STAFF REPORT

CITY OF COLUMBUS PLAN COMMISSION (July 8, 2015 Meeting)

Docket No. / Project Title: PUDF-16-04 (White River Dental)

AWS Properties LLC is requesting a modification to a Final PUD Plan for White River Dental. The request includes updates to signage and landscaping.

AWS Properties COLUMBUS, INDIANA

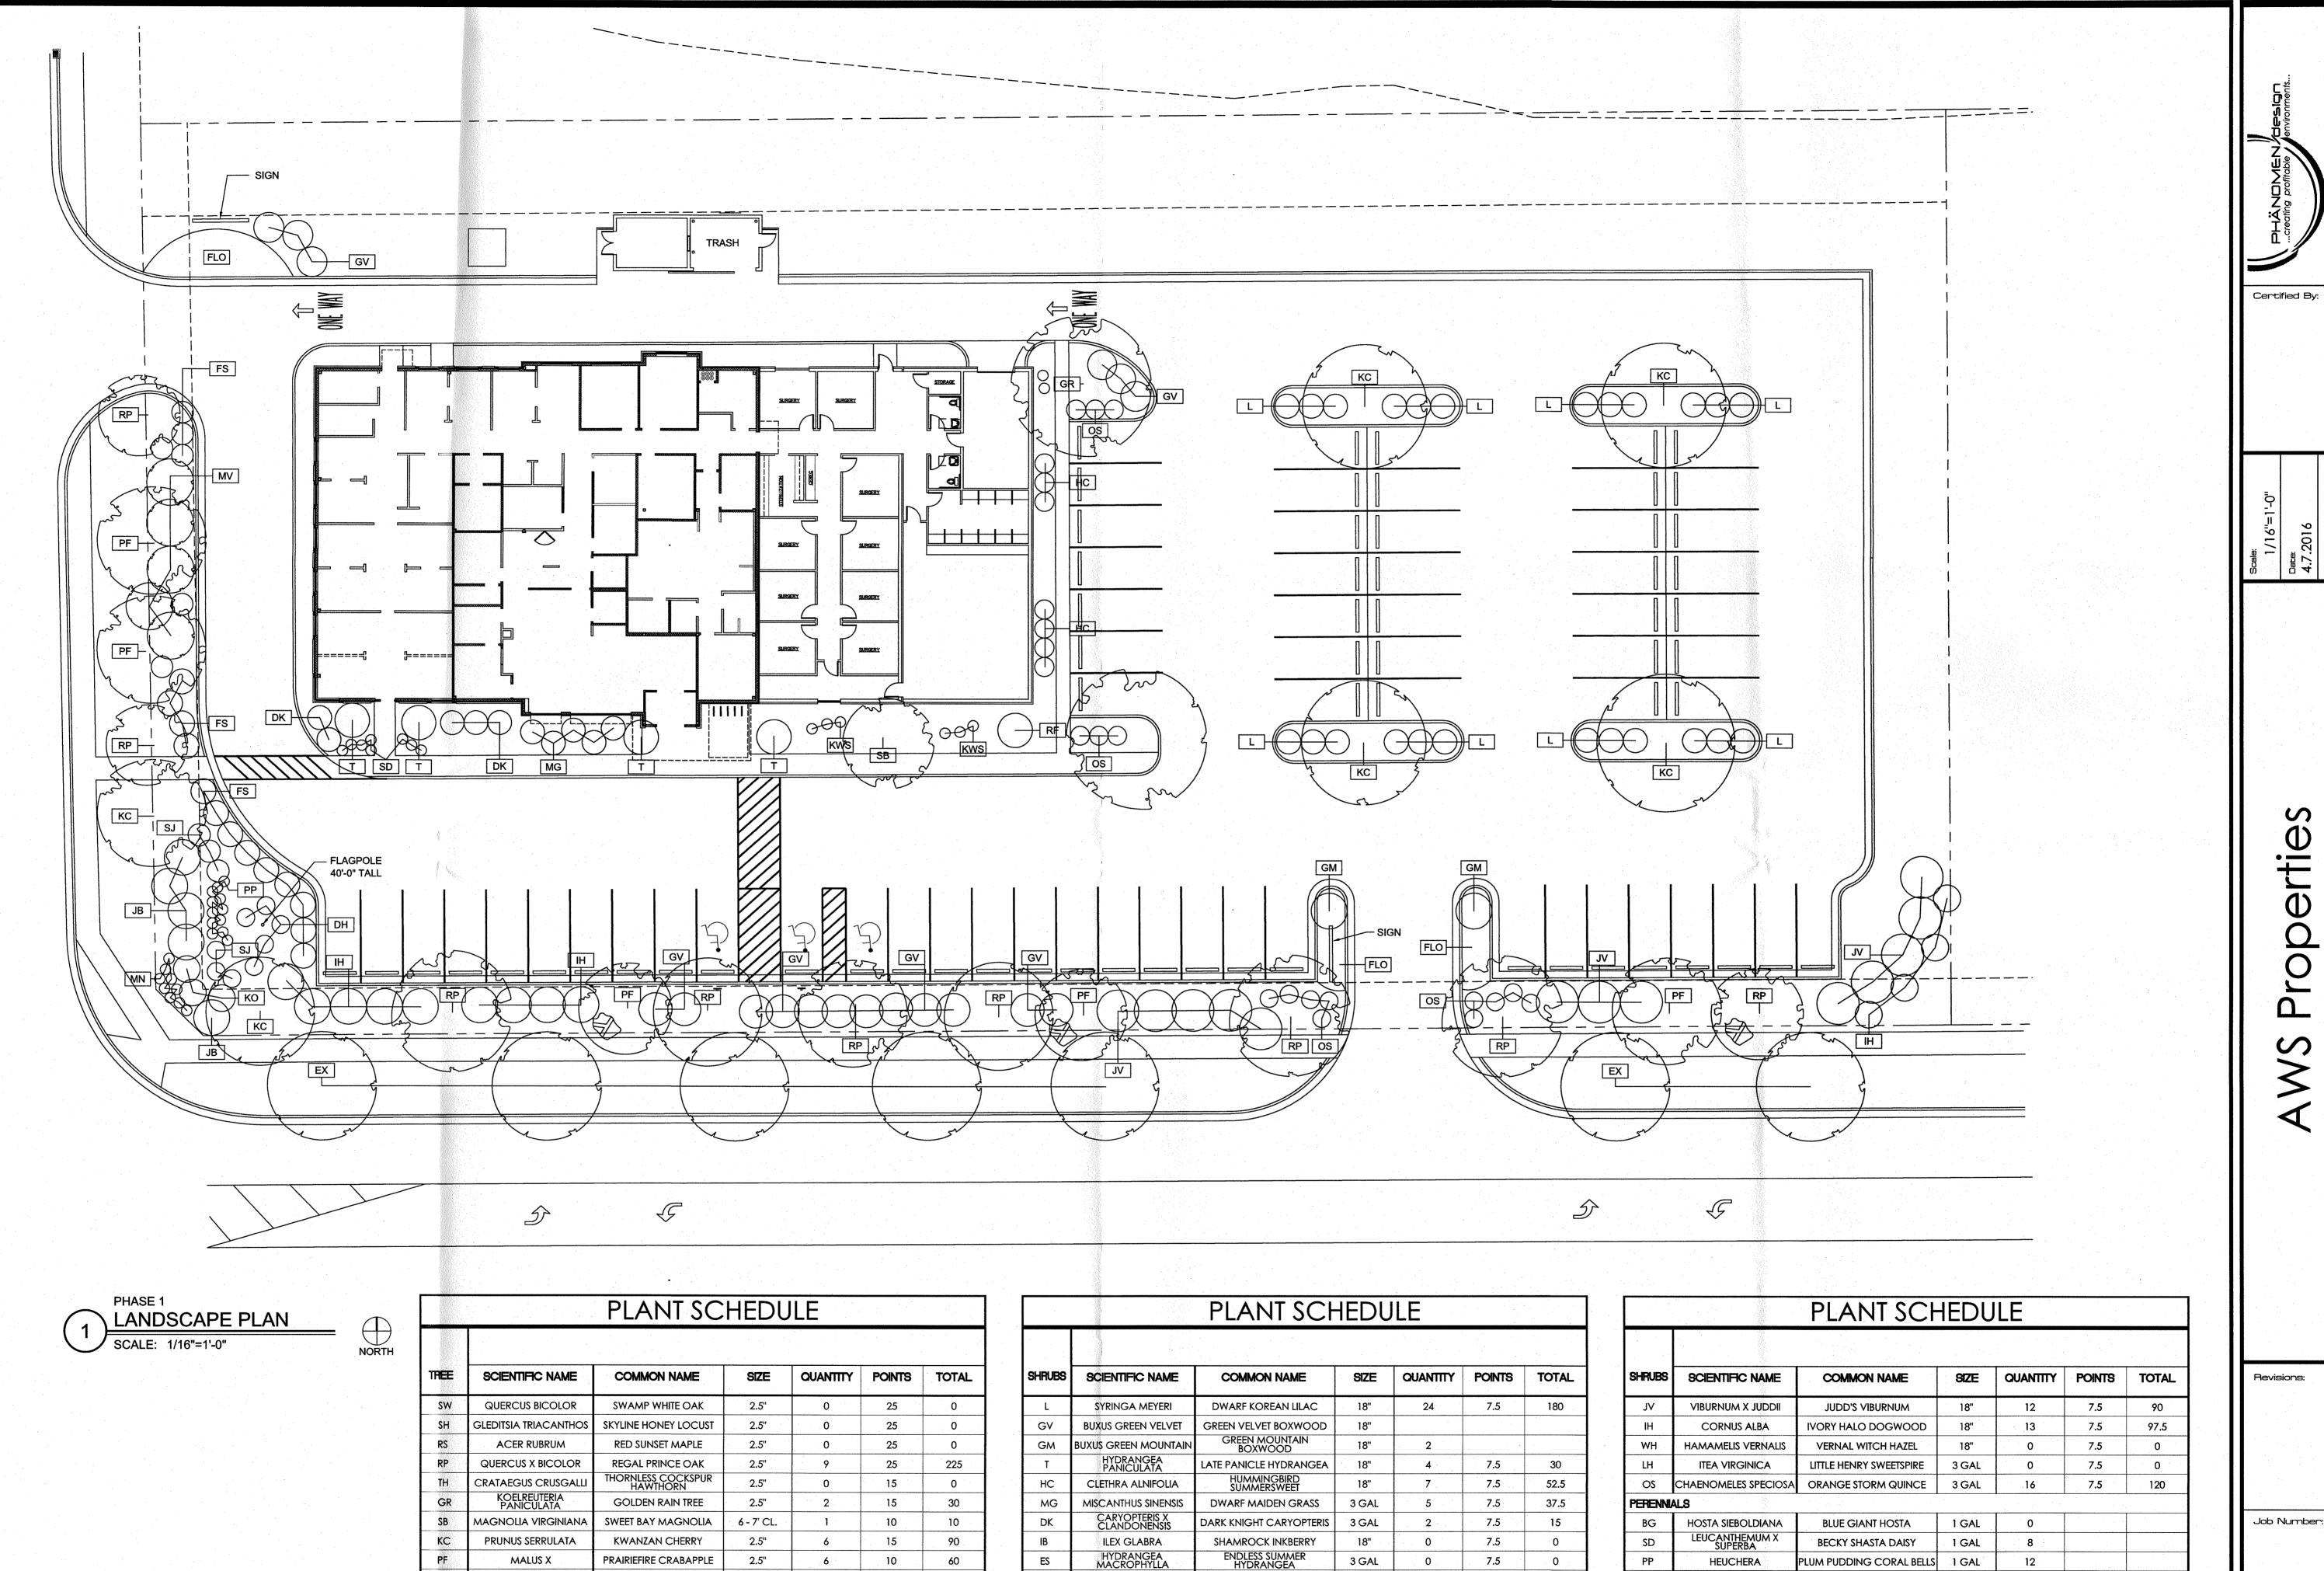
- 4. When comparing this request to the CR (Commercial: Reginal) zoning district requirements, the applicant has provided enough over-all points for the landscaping requirements. The landscaping, however, is not in the appropriate detailed areas as designated by the Zoning Ordinance. The lot interior, and front setback areas have plenty of "landscape points", while the, parking lot frontage, parking lot interior, and signage landscaping do not meet the requirements. The parking lot frontage is deficient one shrub, but the plan has more trees than required. The parking lot interior has enough plants, but the square footage of the planting area is technically too small. The Plan Commission does have the discretion to approve or deny the landscaping plan.

- 5. The previous landscaping plan showed 12 shrubs along the northern foundation of the building. There were also 9 trees and 15 shrubs along the northern portion of the property. These plants helped screen the trash enclosure and parking areas from view from those traveling south along Johnson Boulevard. The proposed landscaping plan does not have any landscaping on the northern portion of the property. The preliminary PUD states that for all buildings on the north side of Merchants Mile, landscaping and architectural treatment shall be along both north and south sides of buildings. The intent behind this is to not have a "back" of the building. It is important to note that there are trees surround the retention pond to the north of the subject property. These trees provide a screening for the northern portion of the building to those traveling south along Johnson Boulevard. It would be beneficial to either retain these trees along the pond, or provide plants along the northern portion of the property. When adding new plants

along the north side of the building, the applicant can move plants from other areas around the site that "exceed" the requirements. For example, there are plants along the parking lot frontage that exceed the requirements for the CR (Commercial: Regional) zoning district. Some plants from this area could move to the north side of the property.

- 1. Landscaping (6 shrubs) shall be required at the base of the 25 foot sign.
- 2. The north side of the property shall have landscaping. The trees along the pond are to be retained, or some landscaping shall be moved to the north side of the building from other landscape areas that have a large amount of landscaping.
